## Answer to referee #1

Sources and pathways of biocides and their transformation products in urban stormwater infrastructure of a 2 ha urban district

Figure 1 changed accordingly:

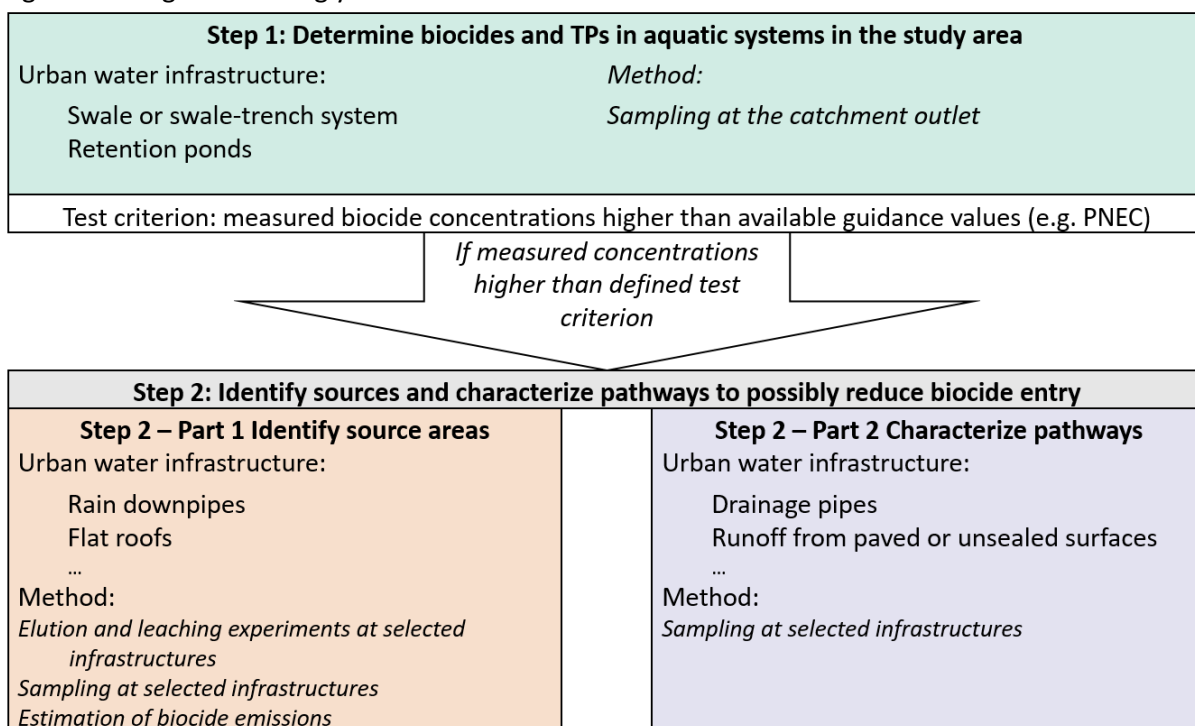
Figure 1 please correct: Step 2 – Part 1 Identify source areas (instead of ‘sources’) –corrected  
 Method: the phrase ‘elution experiments at selected infrastructures’ would facilitate understanding the different methods mentioned here –corrected:

**Figure 4: Daily precipitation about 5 km away from study site between 2015 and 2020. Sampled events are marked according to the two-step approach. Colors correspond to steps. Precipitation data taken from Deutscher Wetterdienst, Station Freiburg.**

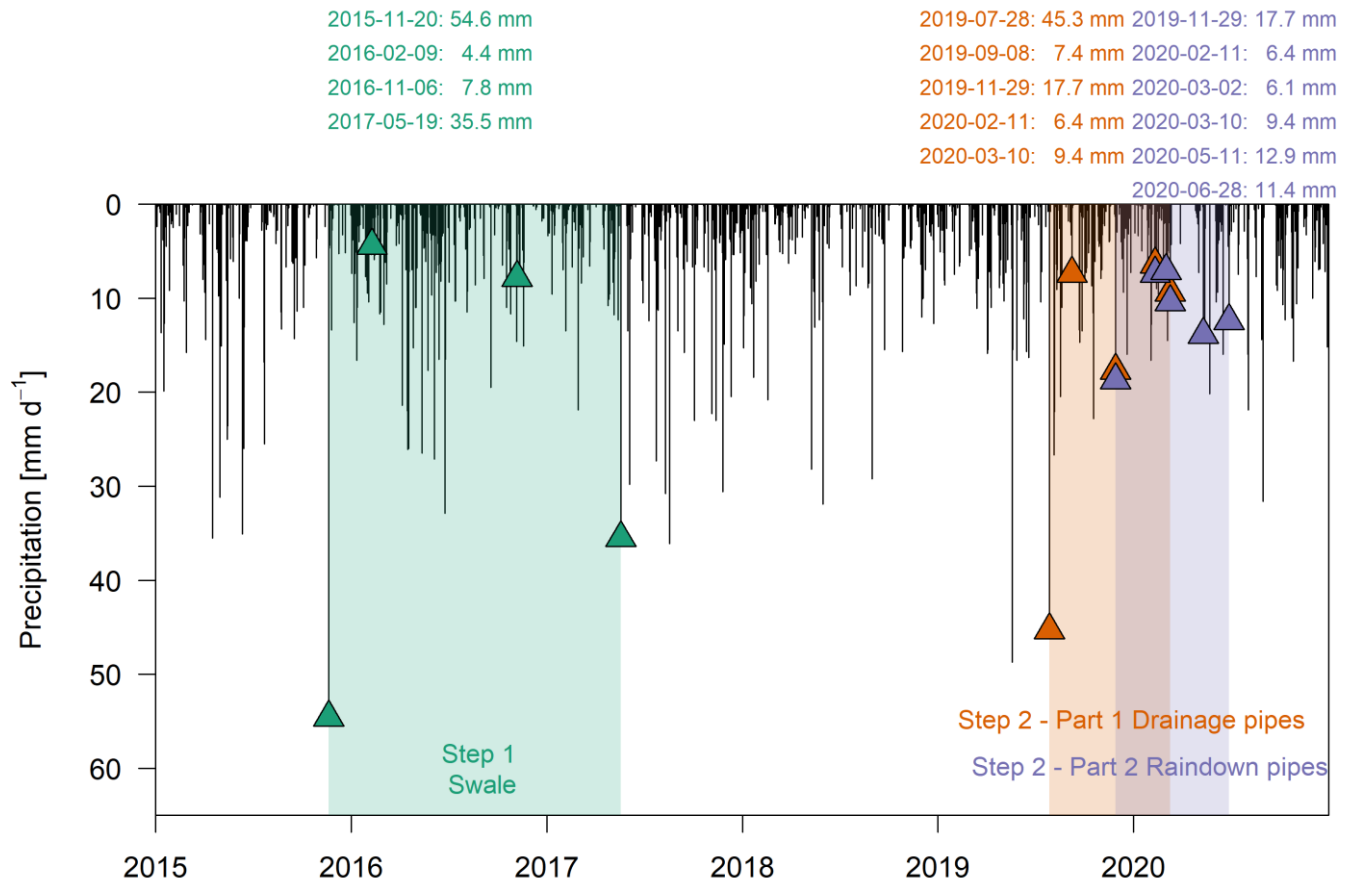
Line 255: Please add weather data elsewhere in studied area/sampling site (methods section). Here you argue about weather conditions in the area but there is no information of it prior this argumentation.

*Figure 4: I am not sure that this figure is really informative since we are not able to read the rainfall for each sampled event. Perhaps put it in supplementary materials*

We did not have a weather station in the immediate district, but relied on a weather station about 5km away from the study area, see 2.3.1. In Fig. 4 we used rainfall data to illustrate rainfall magnitudes during the sampled events. We added the amount of precipitation in an updated figure:

This figure aims to show an overview of the chronology of the sampling. We added the rainfall amounts to the sampled events; see also comments to the referee #1 and #2.

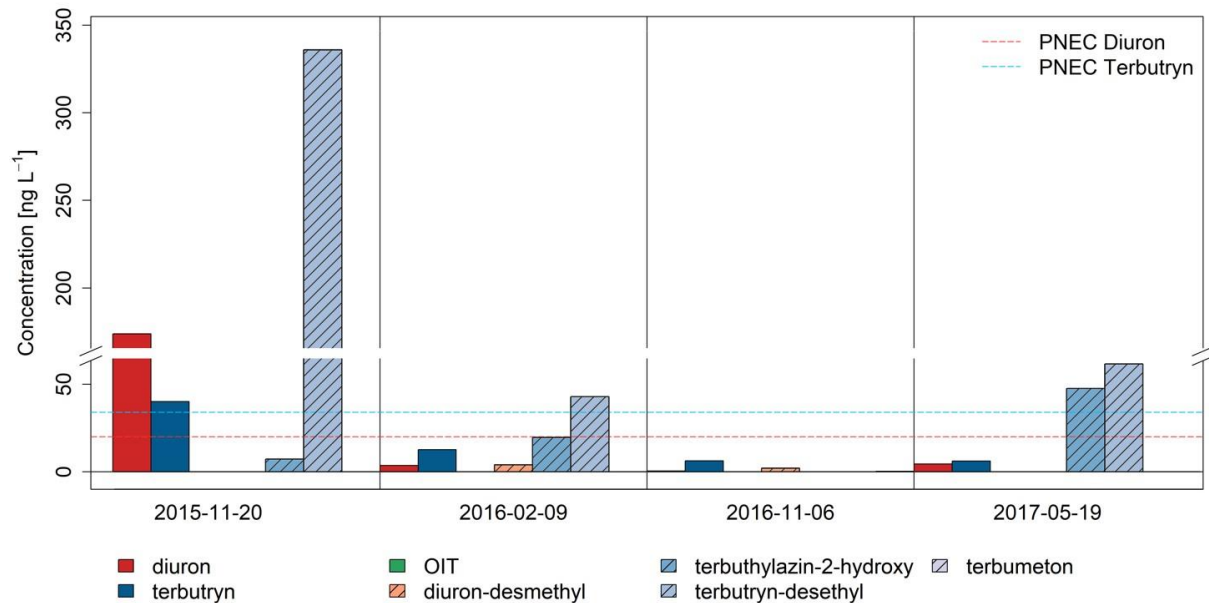
Line 134: I find that “surface water pipe” do not describe well the type of water sampled. It looks like surface water that has been sampled. Perhaps “surface runoff pipe” would be more meaningful

Thank you for your suggestion, we changed the term accordingly.

Changed throughout the manuscript (8x) and in Figure 2 and Figure 3.
